ARLINGTON COUNTY, VIRGINIA

County Board Agenda Item Meeting of May 14, 2022

SUBJECT: U-3468-16-1 USE PERMIT AMENDMENT for a below-grade parking structure with a lighted synthetic turf field above; located at 1601 Wilson Blvd.; (RPC# 16-032-001).

Figure 8: APS Proposed 18th Street North Section

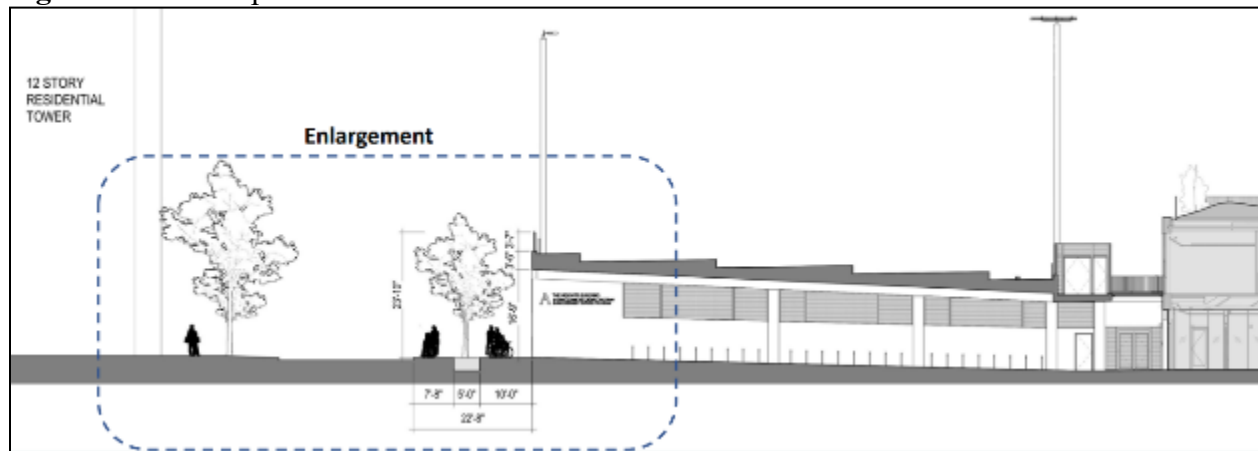
The applicant's proposed 18th Street North segment is not consistent with the WRAP. The WRAP depicts a 39-foot-wide street to include an 11-foot travel lane in each direction, 7-feet of on-street parking on the north side of the street, and a 10-foot-wide bus parking lane along the south side of the street. The WRAP also depicts a 2.5-foot curb and lighting zone, a 10-foot-wide sidewalk, and an optional width for street trees along the back of sidewalk. The WRAP streetscape could support APS's goal for a minimum 7-foot clear landing area by integrating street lighting with the poles used for field lighting at the back of sidewalk on the garage structure.

The County does not support the proposed narrowing of 18th Street North because it does not comply with the WRAP recommendations, and it could cause significant operational issues along the street, impacting APS proposed bus operations without otherwise prohibiting parking on the north side of the street. To prohibit parking on the north side of the street twice a day or more would limit the street's public use to an extent not previously planned or contemplated. This will be discussed in more detail below as part of the discussion section. Staff recommends updating the APS proposal to be generally consistent with the WRAP streetscape and street cross section recommendations.

Figure 11: Phase 2 Proposed Site Circulation and Access

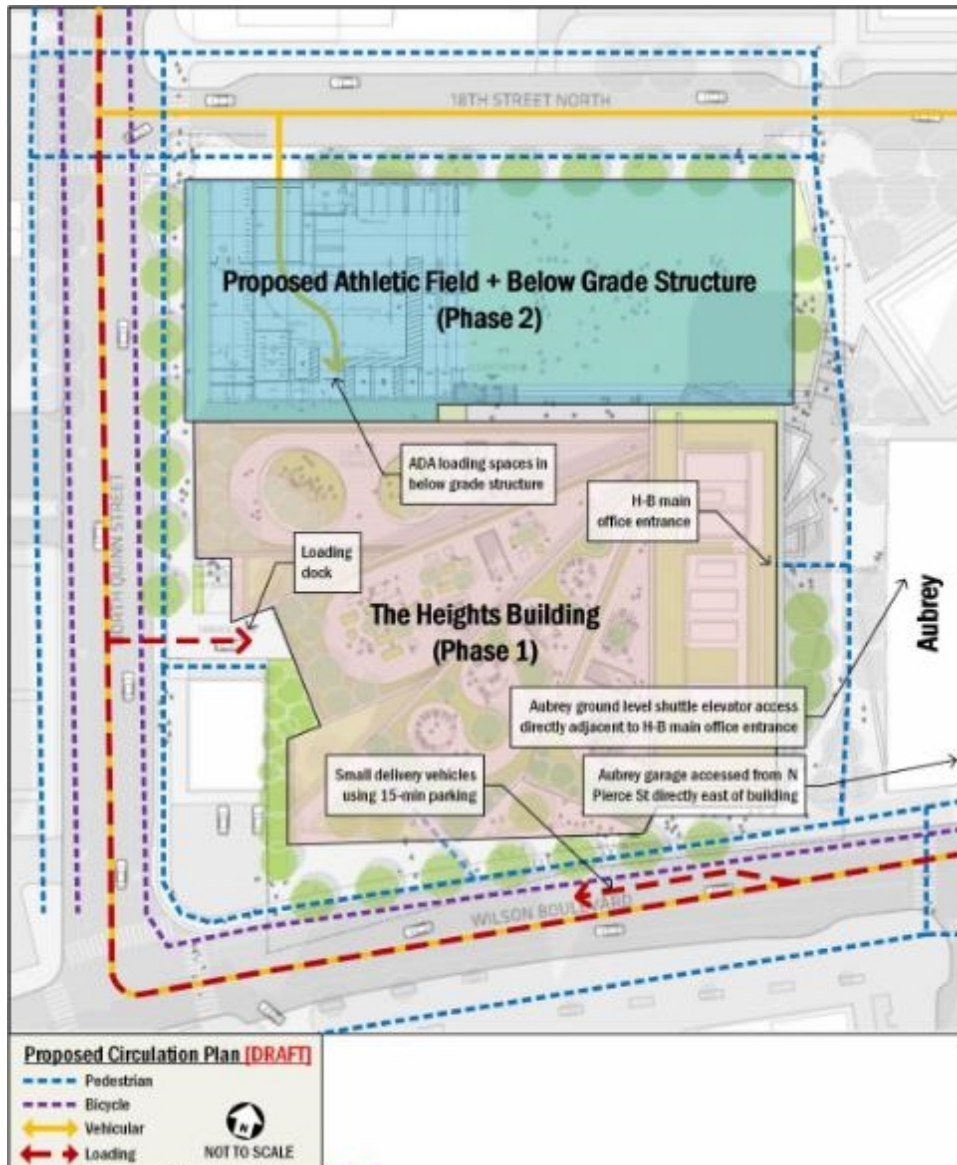
Garage Access – APS has proposed garage access from 18th Street North. This proposed access point would be within the portion of 18th Street North that APS anticipates closing during arrival and dismissal. During this period APS proposes limiting access to the garage to ADA PUDO activities only. The proposed garage access poses a significant operational and safety challenge that APS will have to manage during arrival and departure periods. Arlington County Police and Arlington County Department of Environmental Services do not currently have surplus resources available to manage the closure of 18th Street North twice a day throughout the school year. During the closure of the street, for APS operations, APS will be solely responsible for the safe movement of buses, vehicles, cyclists, students, and other pedestrians within this space. A new condition could require APS to obtain approval for and implement an operations and safety plan for the 18th Street North closures they are requesting to apply 1) during construction, and 2) upon completion of the facility.

Staff recommends that APS be required to develop a comprehensive operations and safety plan for the closing of 18th Street North to apply 1) during construction and 2) upon completion of the facility. The plan should not only demonstrate what type of traffic control will be used (signs, barriers, staffing etc.) but also the staffing and training that will be provided by APS to ensure the safety of students, staff, and the general public. Staff recommends that the County Manager review and approve APS's plan prior to APS being permitted to close the street for exclusive use during arrival and dismissal periods. The operations of the street closure and the associated management and direction of traffic represents a significant safety obligation being assumed by APS with this proposal. APS will need to develop a culture of safety around the operation of 18th Street among their staff. Should APS demonstrate they can't safely control traffic during arrival and departure periods APS may be required to significantly change their programmatic or operational plans for the school to ensure the safety of students and the general public. APS and staff should continue to work on a use permit condition detailing the requirement for an 18th Street North Safety and Operations Plan.

Figure 16: APS Proposed 18th Street North Operations

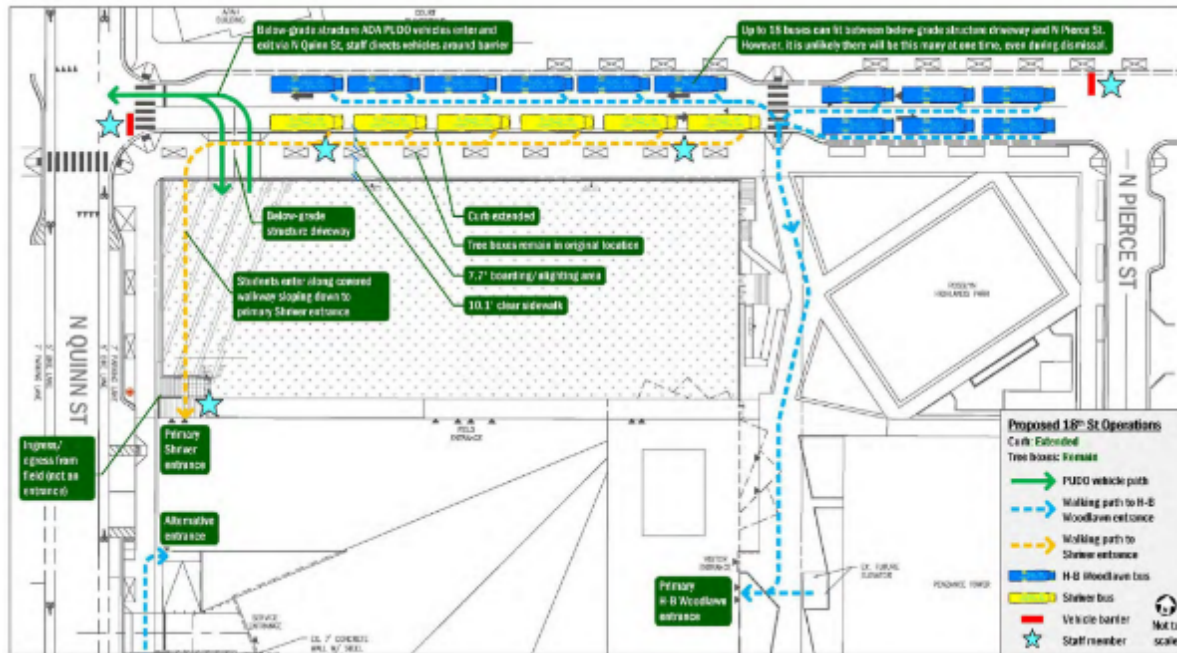
Staff's review of APS's 18th Street operations and design plan has identified two areas of concern along with recommendations to mitigate the concerns.

1. Removal of the parking lane along the school frontage will require removal of all vehicles along the northern parking lane for bus operations to work.
2. The proposed garage entrance increases operational challenges closing 18th Street North during arrival/departure while also permitting limited access into the garage.

By removing the parking lane along the south side of the street APS's proposed bus operations would require parking to be removed from the north side of 18th Street North during morning arrival and afternoon dismissal periods. APS's diagrams suggest that a minimum of 29-feet of street width is required to double stack APS buses and provide safe passage for students between buses. If vehicles remained in the parking lanes during prohibited periods those parked cars would have a significant impact on APS operations. Since the parking would need to be cleared twice daily, the opportunity for APS's operations to be impacted could occur regularly. Additionally, to regularly ticket and tow vehicles multiple times a day could require a significant amount of policing resources that may not be regularly available.

Figure 18: APS Proposed (left) and Alternative (right) 18th Street North Section

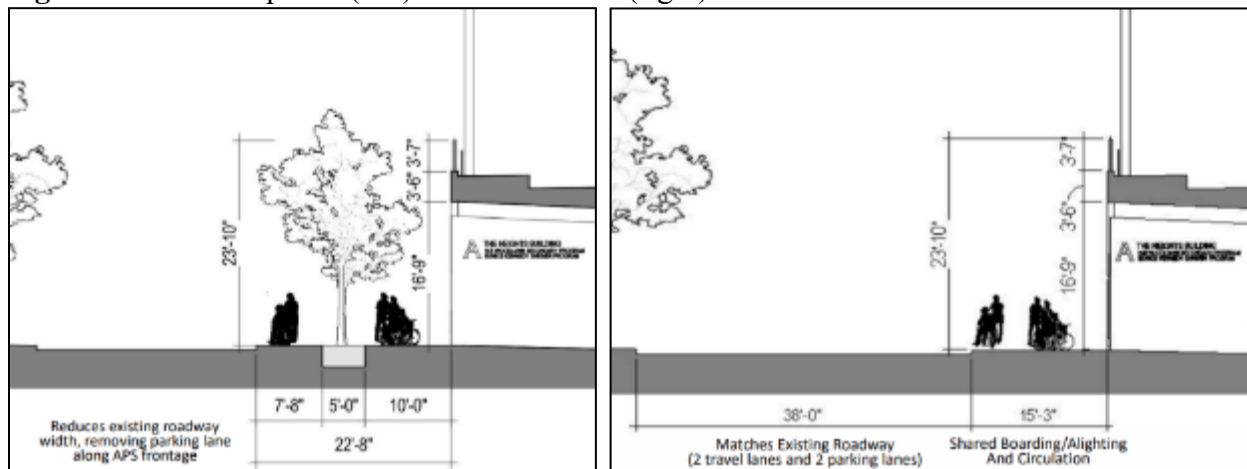
18th Street North Streetscape: APS proposes removal of the parking lane along the south side of 18th Street North adjacent to the school property. The area currently exists as a parking lane and would be incorporated into a revised streetscape proposed to be 22 feet 8 inches wide including a 7-foot 8-inch boarding/alighting zone, 5-foot tree zone, and 10-foot clear sidewalk. As stated above, removing the parking lane is not consistent with the WRAP recommendations and proposed street section for 18th Street North and raises operational concerns.

If the parking lane along the south side of 18th Street North is to remain, the resulting streetscape width from the curb to the face of the parking structure would be 15 feet 3 inches which could

include an 11-foot 3-inch combined boarding/alighting zone and clear sidewalk, and a 4-foot-wide street tree zone along the parking structure's north wall. The streetlights and proposed field lighting could also be combined to maximize the clear sidewalk width. This staff-proposed streetscape treatment along this frontage would support APS operational needs without narrowing 18th Street North and is consistent with the WRAP recommendations and proposed street section for 18th Street North.

Figure 19: Field Elevation along 18th Street North

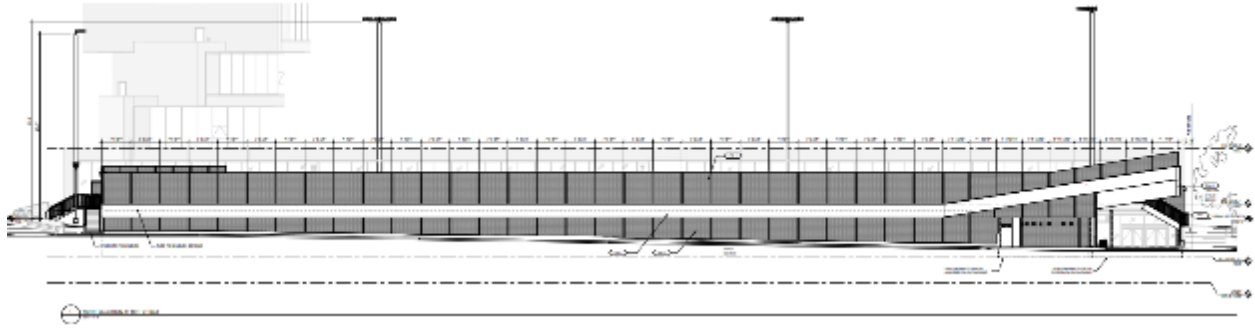
Field Elevation: APS proposes the field at an elevation of 180 feet (above sea level), providing at-grade access to level 1 of The Heights Building but at the expense of public and student access, visibility, and experience along all other sides of the field. When a similarly scoped project was presented in 2017, APS proposed the field at an elevation of 175 feet which provided at-grade field access and visibility from the midpoint of the east field entrance to Rosslyn Highlands Park. Lowering the field elevation could provide many benefits to the site including: improved integration with Rosslyn Highlands Park, enhanced access, visibility, and public edge conditions along North Quinn Street, 18th Street North, and Rosslyn Highlands Park, improved street tree conditions along 18th Street North, better natural lighting conditions for ground level Shriver Program classrooms, and greater visibility of the school's architecture from the public realm.

Staff recommends APS explore field elevations less than 180 feet which are closer to the elevation and field entrances proposed in 2017 to balance and improve public and student access, visibility, and experience along all sides of the field.
